Extraordinary Circumstances and Plans Demand Extraordinary Care in Approval. 21A-0141E

Gas: Save 100s of Millions and Improve Capability by Upgrade Old vs Buy New High Renewables/Storage, and WEIS Change Everything

CORRECTED (bottom page 10, top page 11) 12/6/23

Kenneth Regelson Ken@EnergyShouldBe.org

Curtailment in Context - WEIS Experience

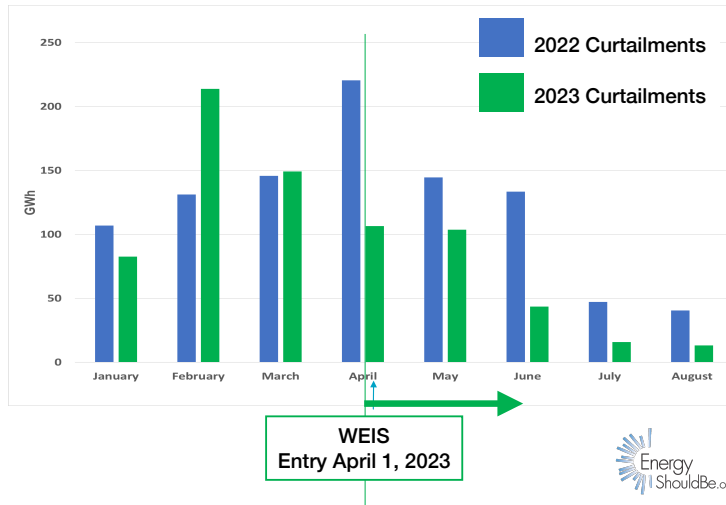
Curtailments as a percentage of Potential Production are down 48% YoY since joining WEIS in April

Most Colorado grid aware folks understood that the generation mix would change. One surprising change is the reduction in monthly generation of Platte River Power Authority's 280 MW Rawhide coal plant to about half of its previous monthly generation.

WEIS - A Big Change for PRPA's Rawhide 1 Coal Plant

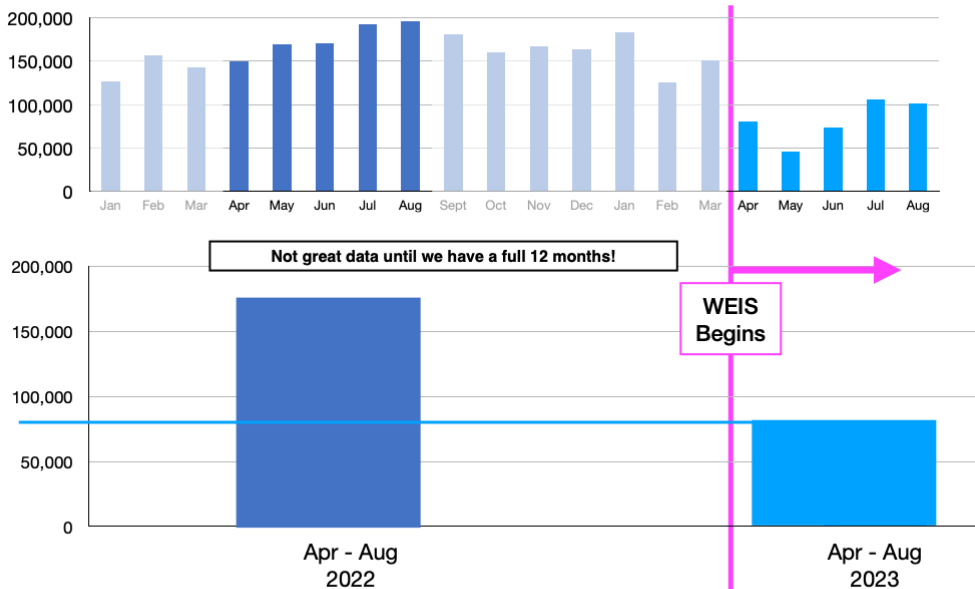
Since WEIS is difficult or maybe impossible to get energy production for a single unit, to create the above chart I had to resort to EIA Form 923 data.¹⁰

As Colorado has required very high levels of renewables, it is quite surprising that the utility players in WEIS's market do not know what the percentage of clean vs. dirty energy they get when they purchase from WEIS. Clearly this must be fixed to understand what WEIS's impact is.

What other surprising results can we expect from WEIS when we can actually see the generation mix by generator we can only guess at. And guessing when data should exist can be extraordinarily expensive.

I believe the PUC should compel WEIS to publish on the web detailed hourly operational data by generator and what renewable mix is delivered so that the public may understand what its impact is.
